**Economic Commission for Europe****Administrative Committee for the TIR Convention, 1975****Technical Implementation Body****Fifth session**

**eTIR conceptual, functional and technical specifications:****Version 4.3****Minor corrections included in revision 2****Note by the secretariat****I. Introduction**

Figure 11  
Record declaration data activity diagram

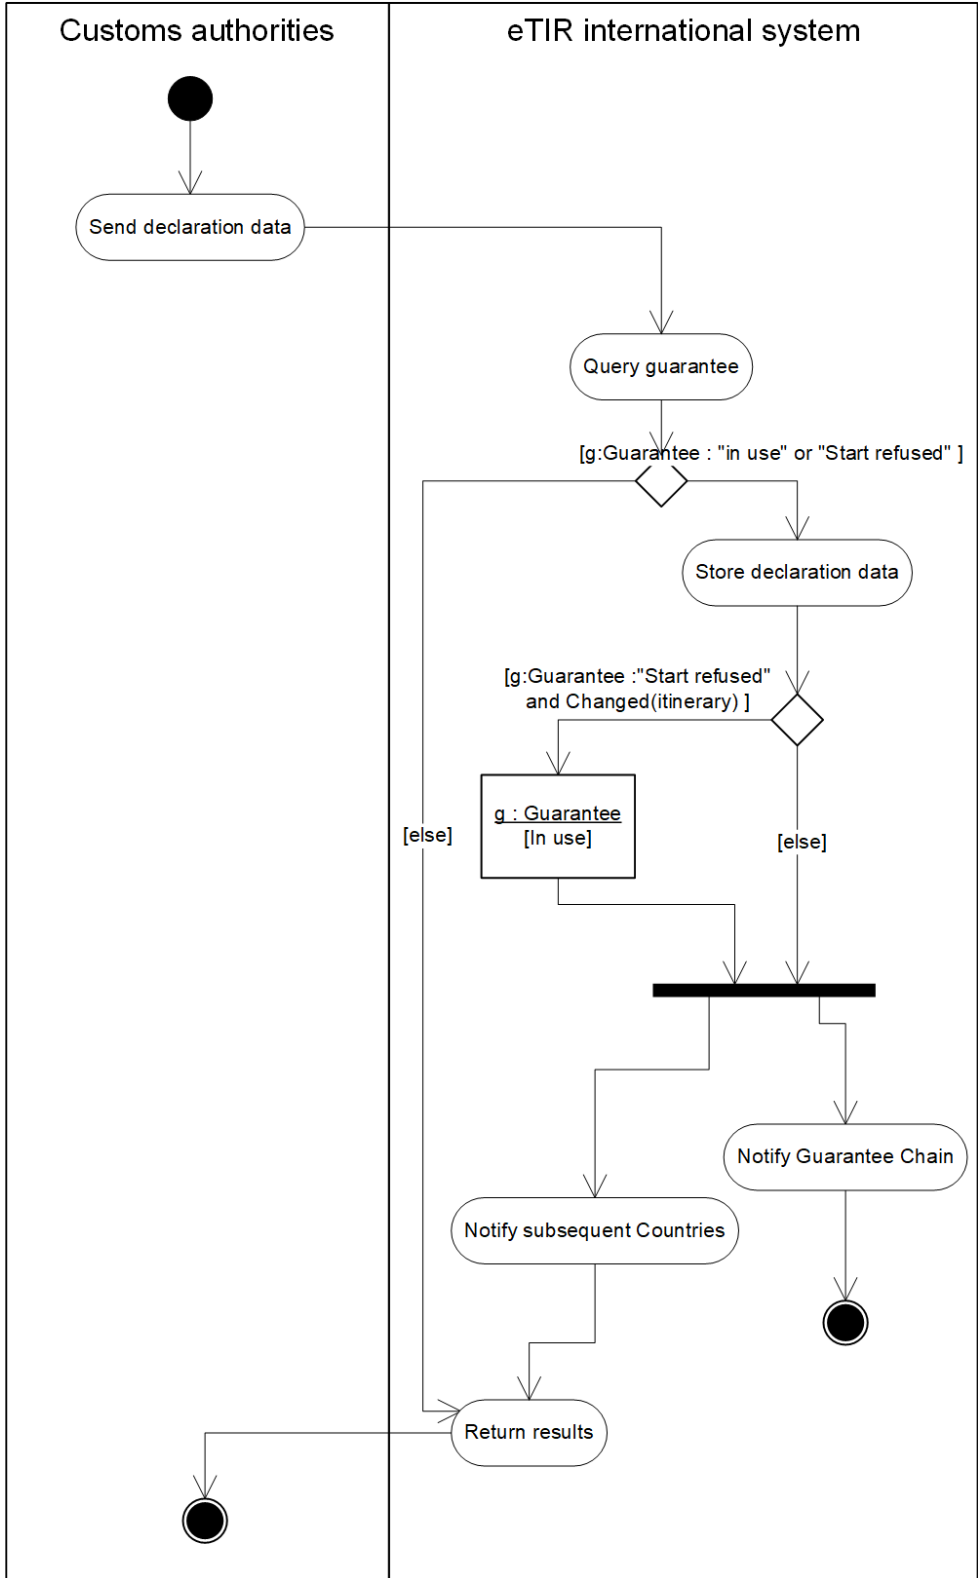
7. Various changes had to be introduced in Table 7, 8 and 9 as well as in Figures 11, 12 and 13 because of the following reasons:

- Annex 11, Article 10, paragraph 1 states clearly that the eTIR procedure cannot be started in fallback mode
- Seals information is transmitted by means of the I9 and I11 messages
- The accompanying document contains information on seals and is reprinted when they are changes, e.g. after customs controls (see Functional specifications Chapter IV.1.1.1).
